Rezoning Application:

PD 22-1577

Development Services Department

1.0 APPLICATION SUMMARY

2.4 Proposed Site Plan (partial provided below for size and orientation purposes. See Section 8.0 for full site plan)

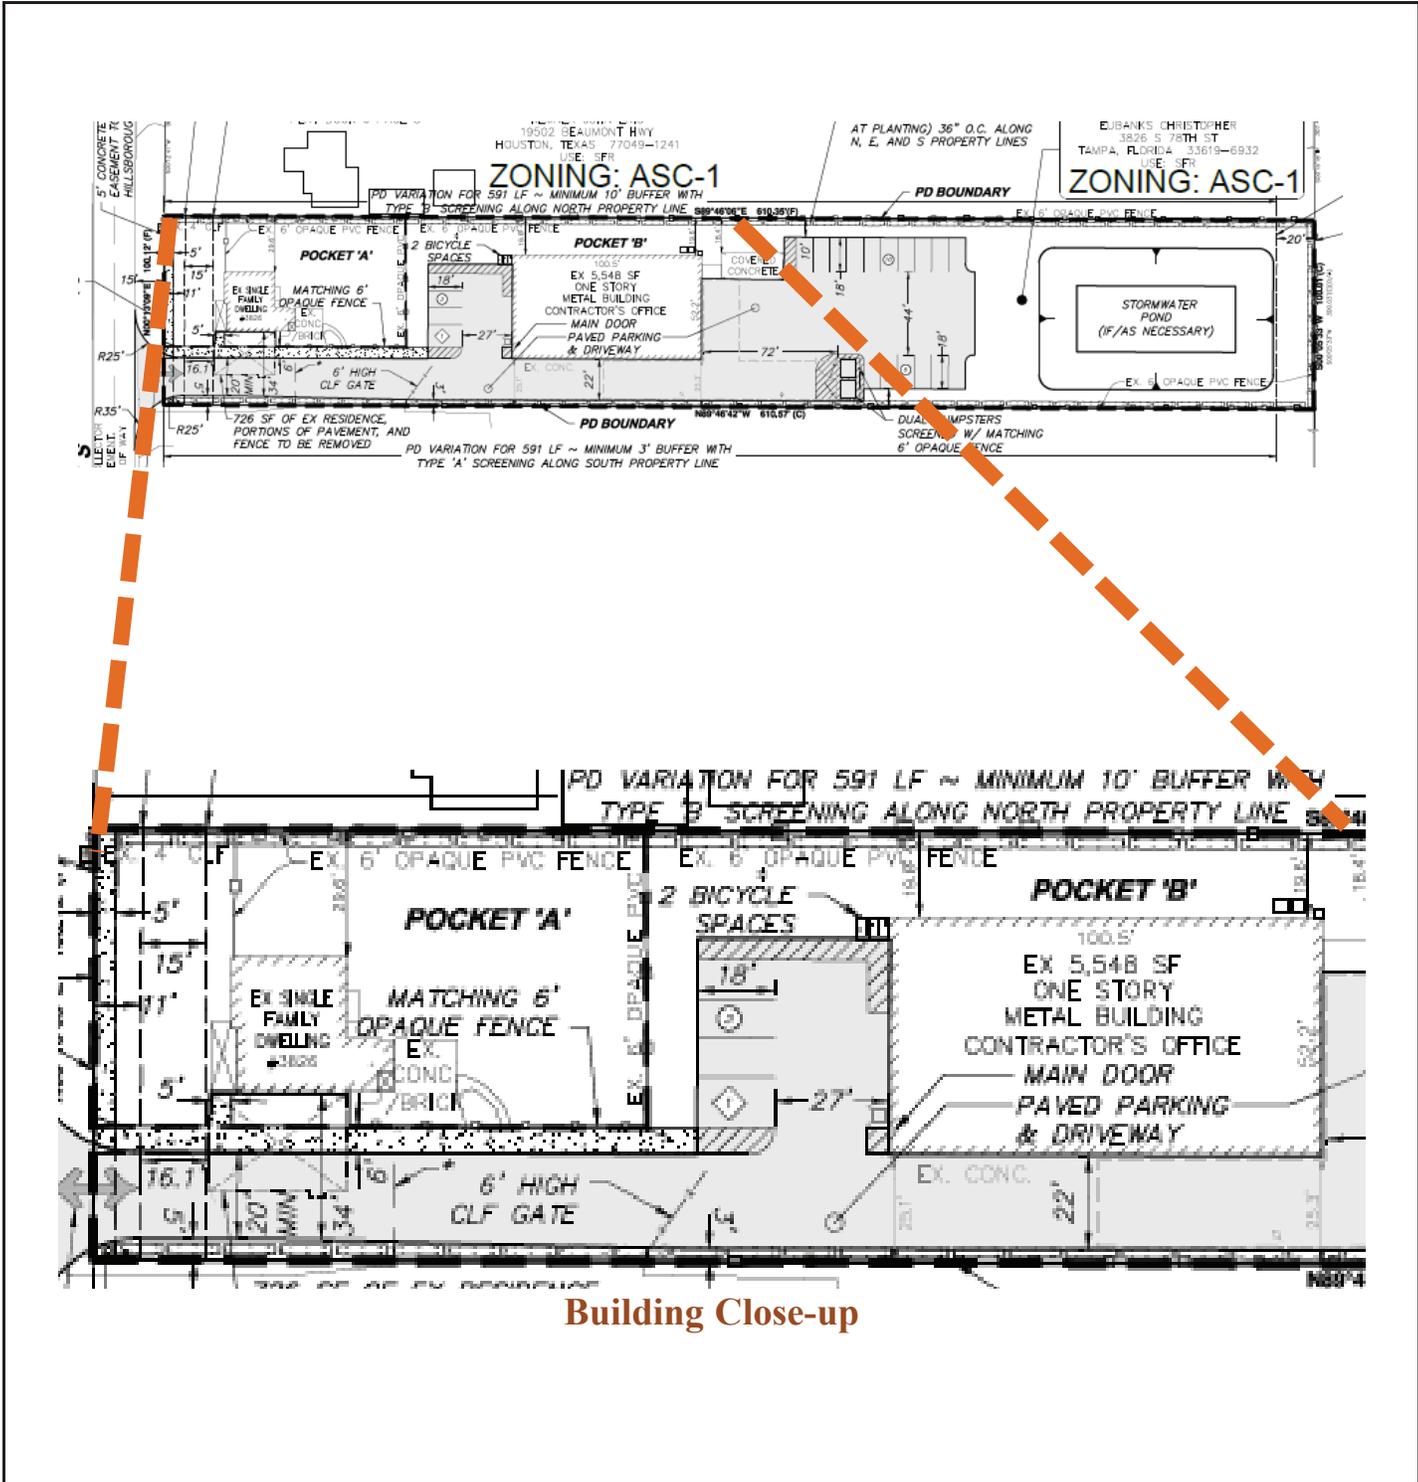
- Prior to PD Site Plan Certification, the applicant shall revise the PD Site Plan to:
 - Correct the CIP project number from “69644001” to instead read “69666000”; and,
 - The developer shall add an access arrow along the southern property boundary as generally shown below and label as “Future Access to Shared Access Facility – See Conditions of Approval”.

Figure 1: Vehicle Tracking Exhibit

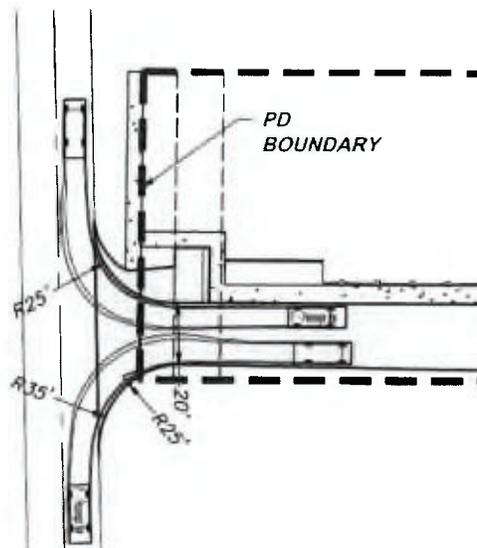
Driveway Width - Request made for the driveway width to be reduced to 20 feet for residential lanes instead of 24 feet for commercial uses, as per TD-7 of the Hillsborough County Transportation Technical Manual. Given the lower trip generation of the proposed use and the design vehicle, there is no conflict at the driveway with two way directional traffic. See Figure 1 below which depicts maneuvering capabilities within the 20-foot wide section of the driveway/drive aisle.

Figure 1: Vehicle Tracking Exhibit

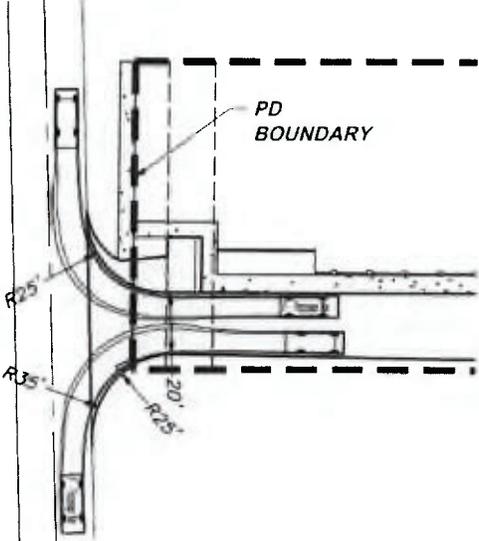
Driveway Width - Request made for the driveway width to be reduced to 20 feet for residential lanes instead of 24 feet for commercial uses, as per TD-7 of the Hillsborough County Transportation Technical Manual. Given the lower trip generation of the proposed use and the design vehicle, there is no conflict at the driveway with two-way directional traffic. See Figure 1 below which depicts maneuvering capabilities within the 20-foot wide section of the driveway/drive aisle.
